RE: DUANE ARNOLD ENERGY CENTER

Subject: Additional Effects of Core Flow on ECCS LOCA Analysis

"REQUEST FOR ADDITIONAL INFORMATION"
CONCERNING
"ADDITIONAL EFFECTS OF CORE FLOW ON ECCS LOCA ANALYSIS"

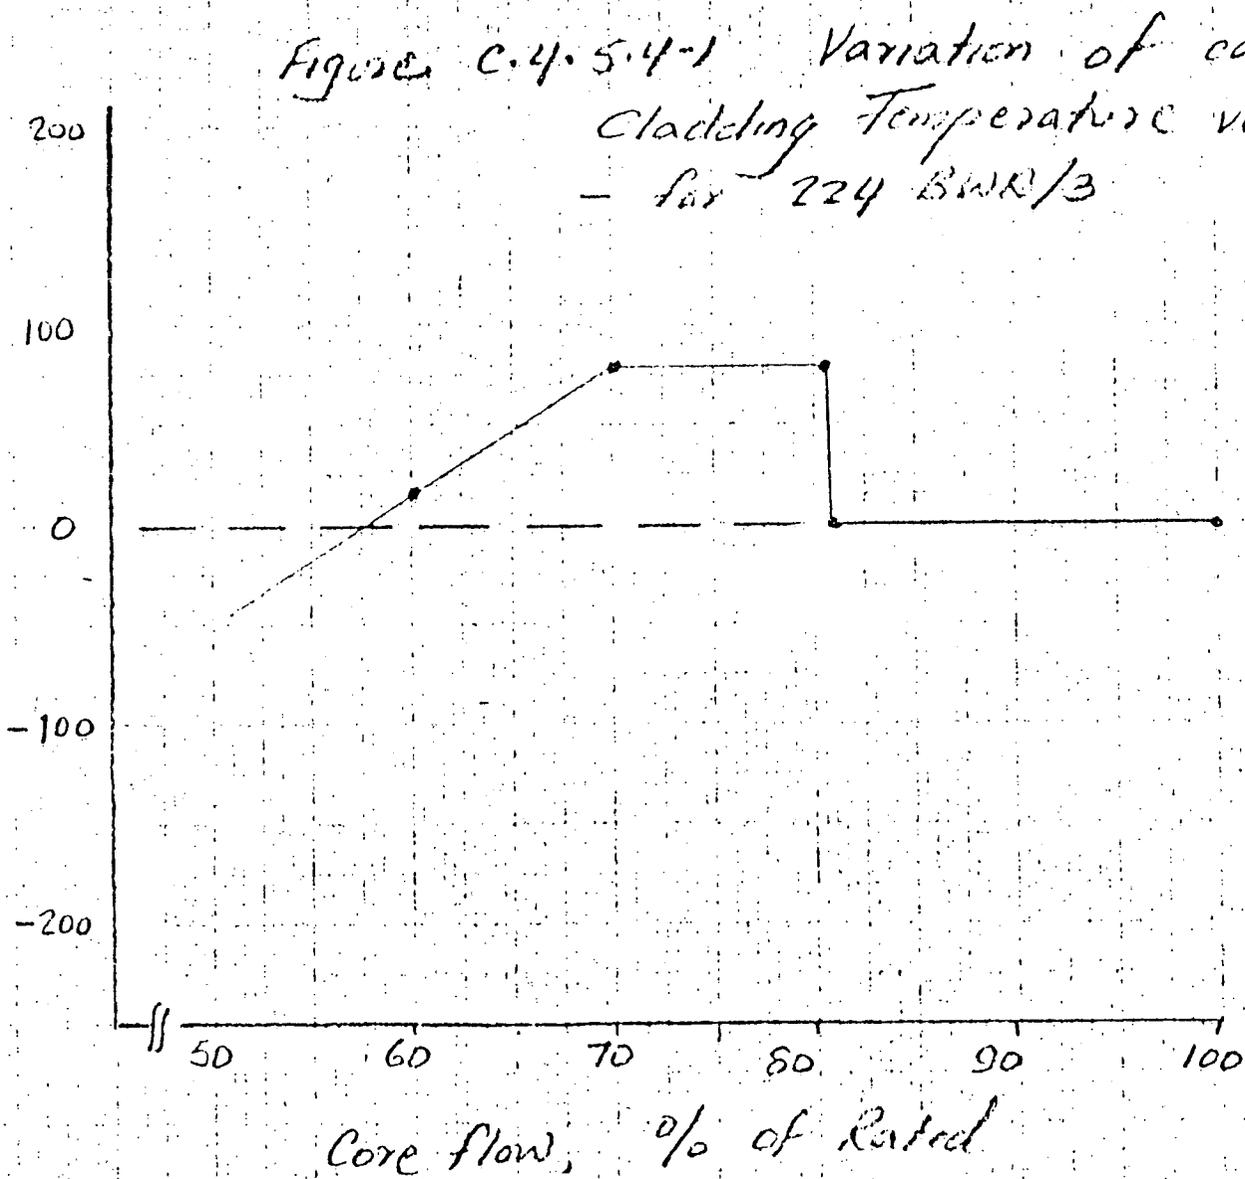
7. Explain why Figure C.4.5.4-1 indicates the early DNB occurs at <81% core flow for a 224 inch BWR/3, whereas Figure C.4.5.4-3 indicates the same for <90% flow, and Table C.4.5.1-3 indicates the effect begins between 85% and 90% flow.

FIG. C.4.5.4-2

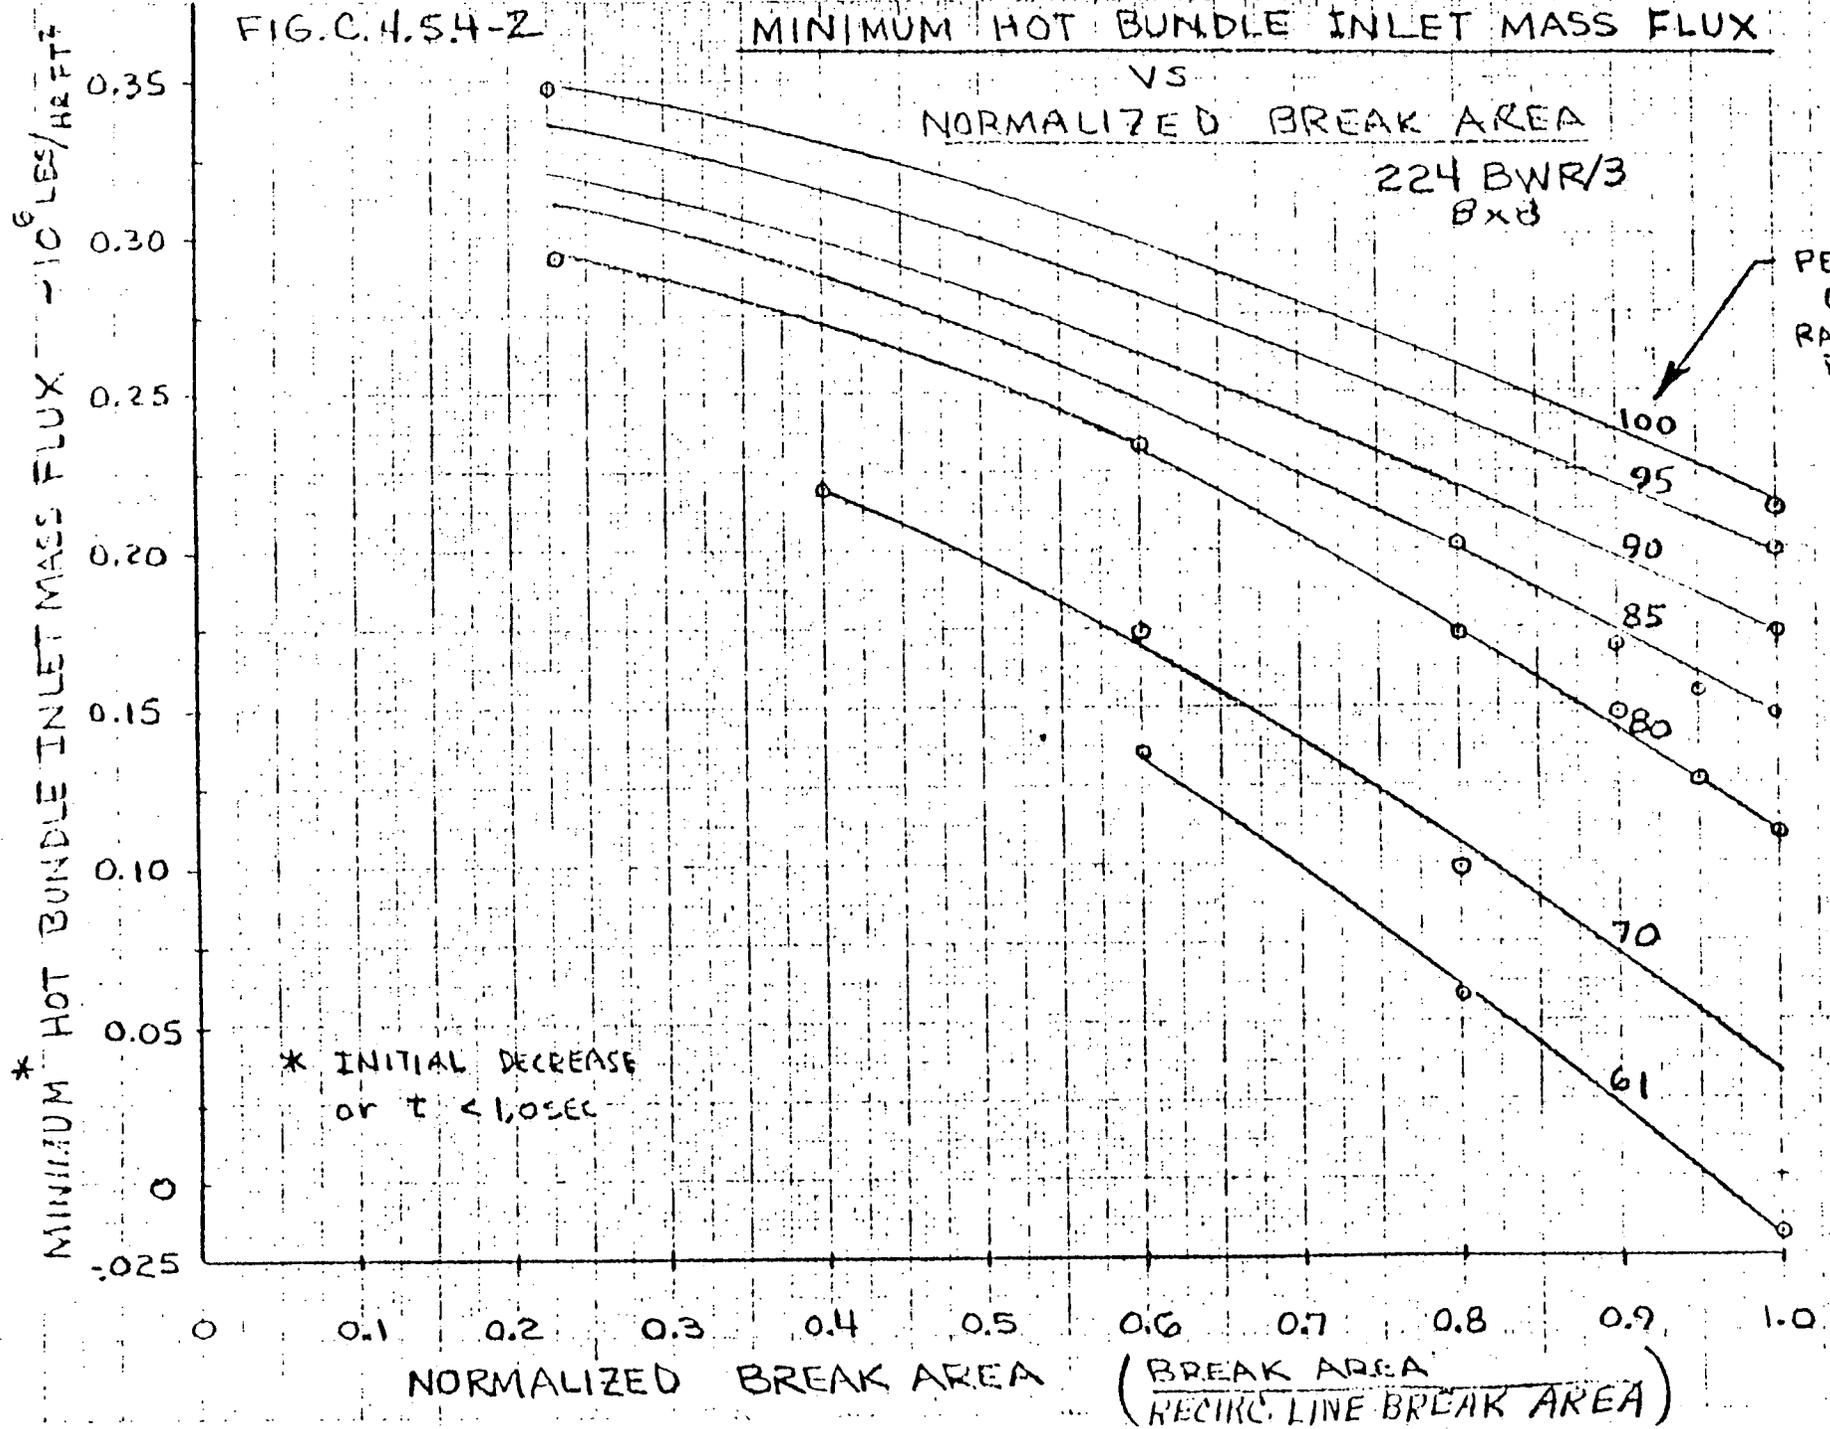
8. Describe whether or not all of the plotted points on Figure C.4.5.4-2 represent specific calculations using the LAMB code for the flow and break areas indicated. (19 individual LAMB runs are indicated).
